WCAP-16793-NP, Rev.0 (Non-Proprietary)
Project No. 694

March 2, 2009

OG-09-84

Subject: Pressurized Water Reactor Owners Group
Responses to the NRC Request for Additional Information (RAI) on WCAP-16793-NP, "Evaluation of Long-Term Cooling Considering Particulate, Fibrous and Chemical Debris in the Recirculating Fluid" (PA-SEE-0312)

———— SWITCH OVER TIME
- - - - BOILOFF RATE
- - - - CORE INLET FLOW

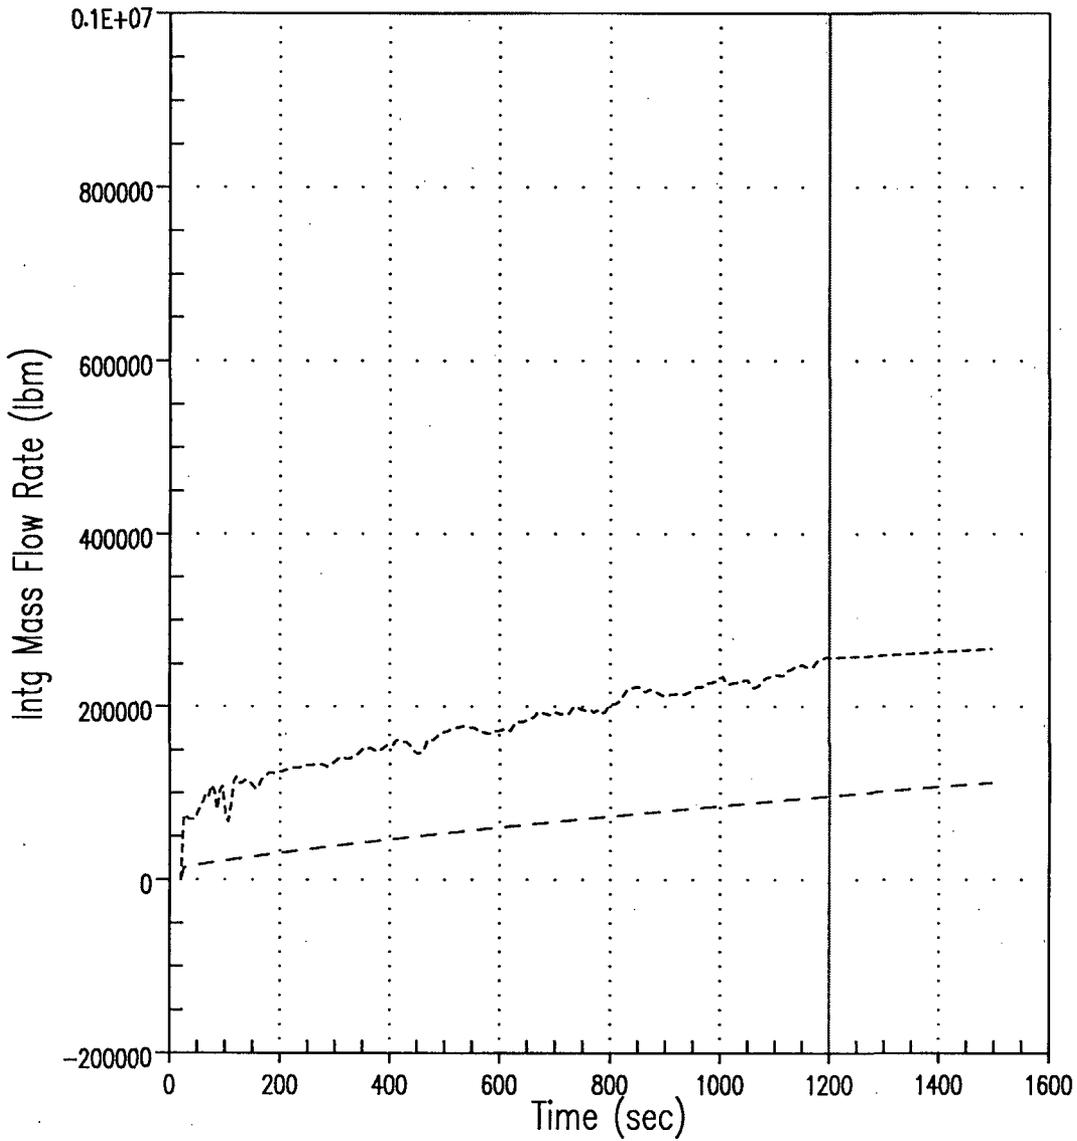
- 1) WCAP-16793-NP, Appendix B, presents analyses of the effect of core inlet blockage using the WCOBRA/TRAC analysis code. Since the report was prepared additional analyses have been performed to determine the blockage level that would reduce core flow below that necessary to match coolant boil-off. Please provide documentation of the additional analyses that have been performed, including figures, for the integrated core inlet and exit flow, peak cladding temperature, core collapsed liquid level, core exit void fraction, and core pressure drop for the bounding conditions. The results should be presented for each case analyzed up to and including the blockage level for which boiloff is no longer satisfied.

The first flow reduction run performed reduced the hot channel (Channel 13) flow area by 50%, which yields a total core inlet flow reduction of 99.7% compared to an unblocked core. The requested plots for this case are shown in Figures 1 through 7. Figures 1 and 2 show comparisons of the integrated core inlet flow and the core boil-off rate. As shown, even with the increase in core blockage, the flow that enters the core is still in excess of the boil-off rate. Figure 3 displays the integrated liquid flow at the core exit. The figures illustrate that, although liquid in excess of that needed to keep the core quenched enters the core, every little liquid flow is present at the core exit after the blockage occurs. The Peak Cladding Temperature (PCT) is shown in Figure 4. There are no significant PCT excursions after the core is blocked. Figure 5 displays the collapsed liquid level of the average assembly core channel (Channel 11 of Figure 6.3.4-3 in Reference 1). The figure shows that the collapsed liquid level drops slightly at the time blockage occurs, however, the liquid level continues to increase even after the blockage to the hot channel (Channel 13) is fully implemented at 1230 seconds. The void fraction at the core exit shown in Figure 6 again illustrates that liquid is present at the top of the core which shows the flow that enters the core after blockage occurs is still in excess of the boil-off rate. The core pressure drop is displayed in Figure 7. The figure displays an increased pressure drop of roughly 2 psi as blockage at the core inlet is increased. As the conditions in the Reactor Coolant System (RCS) adjust to increase in core blockage, it is noticed that the core pressure drop fluctuates consistent with the core liquid level.
